PZ21-00007 (DEV) Navajo Lofts  
Summary Sheet

**Project Summary:** **Construction of a 60-unit townhome development (Navajo Lofts)**

**Re: Plan Review Comment Responses – 2<sup>nd</sup> Review**

**Subject:** Navajo Lofts  
10 Navajo Drive  
**Plan Review APN #** 408-24-536B     **Zoning:** CO  
**Response Date:** 11-15-2021

SITE PLAN

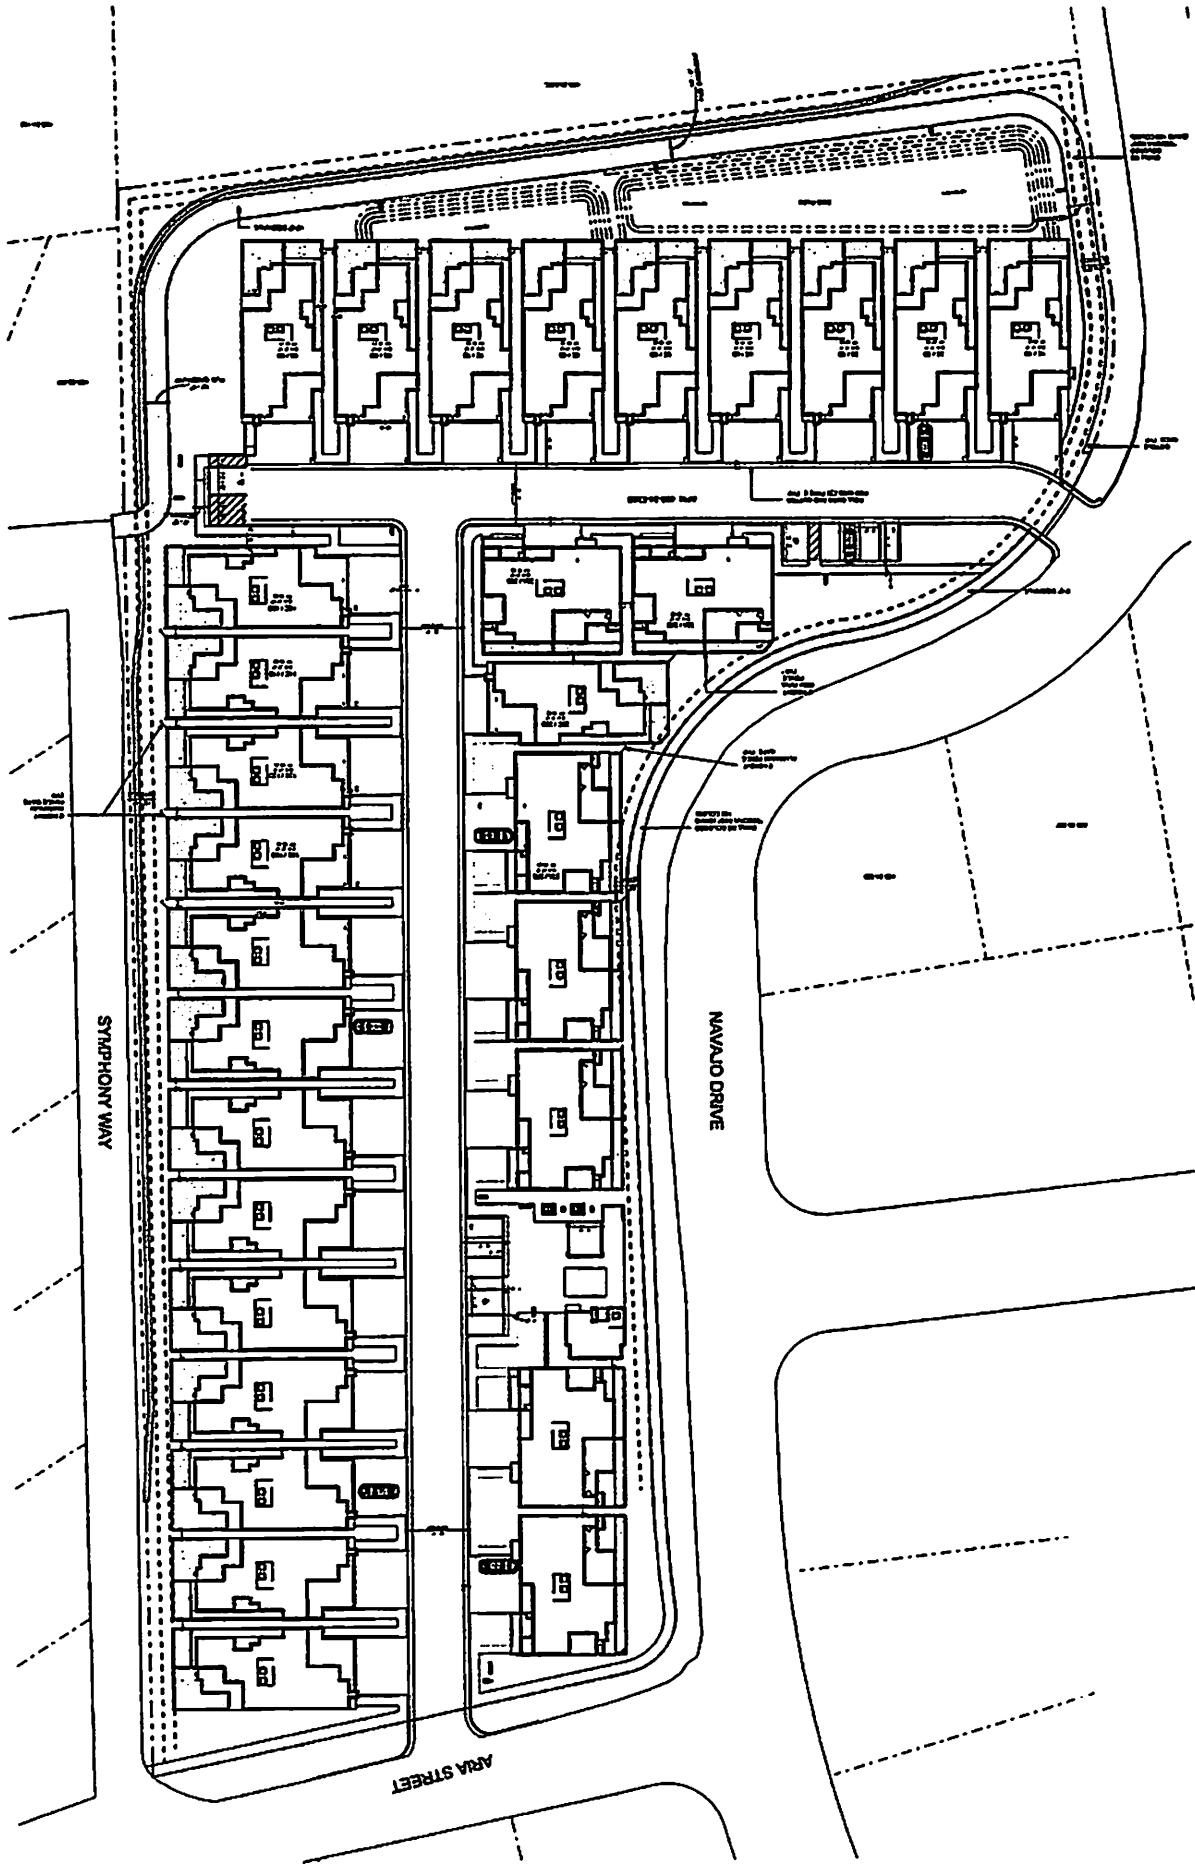
The January 5th letter mentions a swimming pool, but we can't see that detail on the "Site Plan."
